PIC24FJ128GA310 Family Silicon Errata and Data Sheet Clarification

The PIC24FJ128GA310 family devices that you have received conform functionally to the current Device Data Sheet (DS30009996G), except for the anomalies described in this document.

Data Sheet Clarifications

The following typographic corrections and clarifications are to be noted for the latest version of the device data sheet (DS30009996G):

64-Lead Plastic Quad Flat, No Lead Package (MR) – 9x9x0.9 mm Body with 5.40 x 5.40 Exposed Pad [QFN]

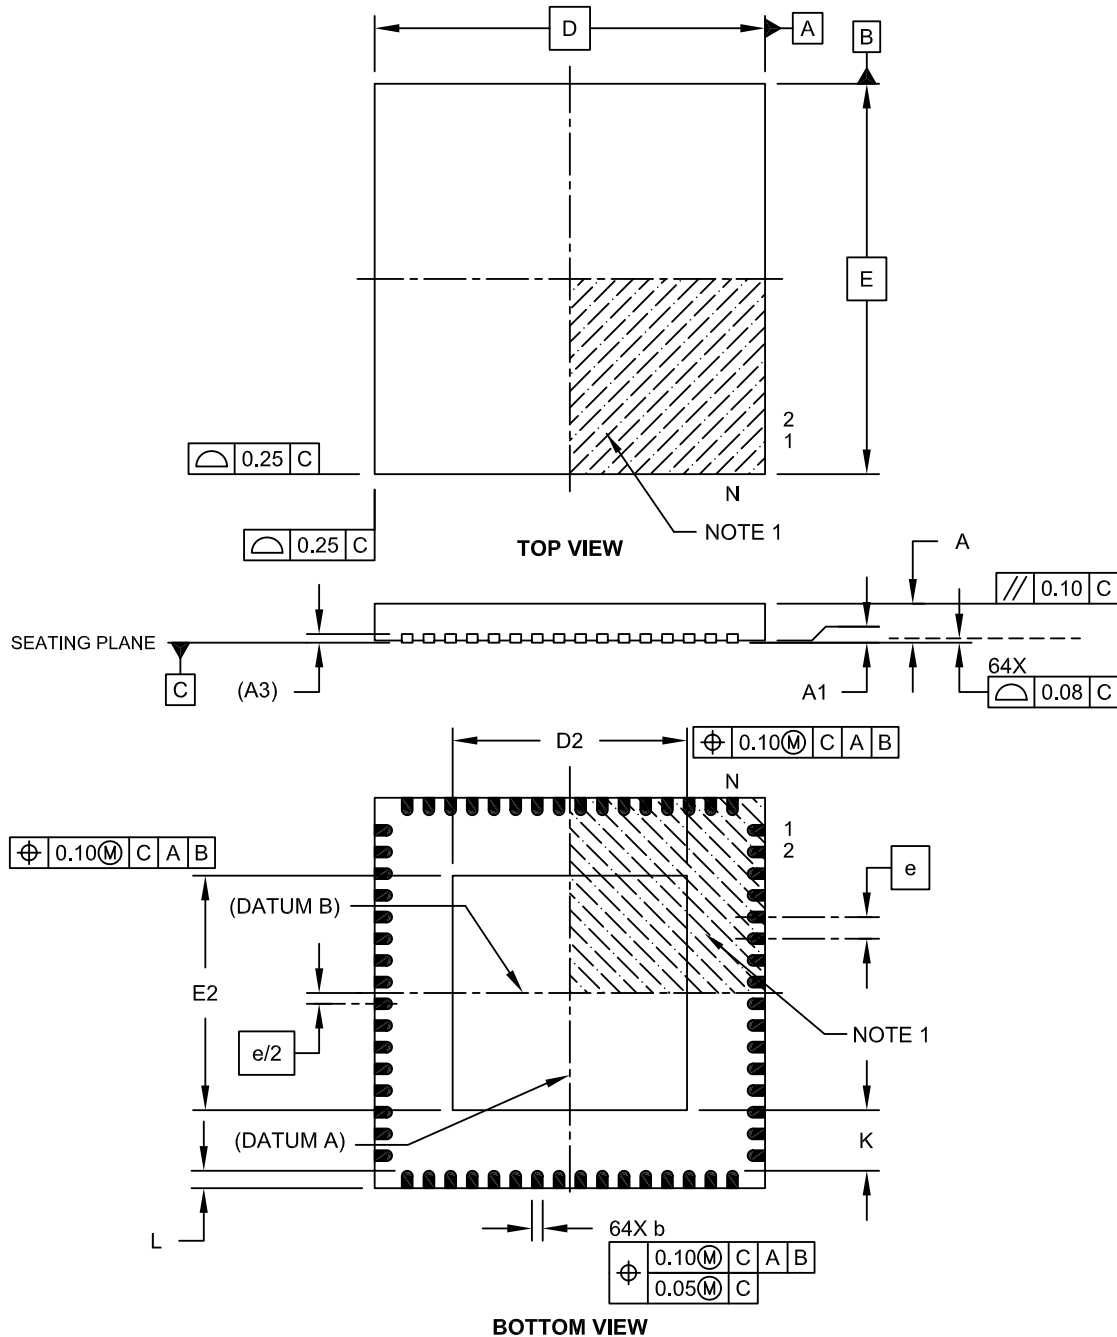
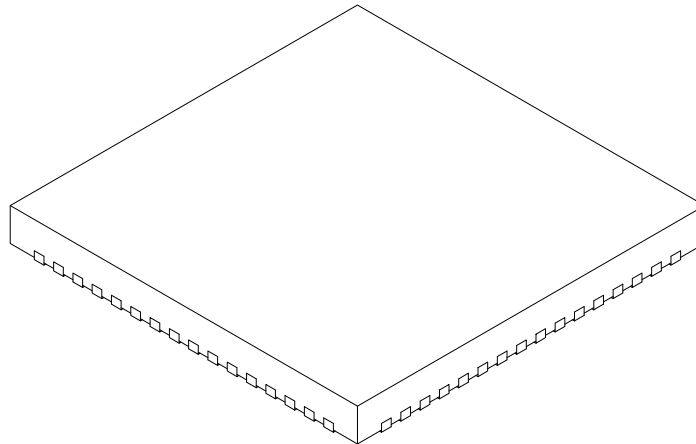
The 64-Lead Plastic Quad Flat, No Lead Package (MR) drawings on Pages 391 through 393 have been replaced with the C04-154A package drawings shown below.
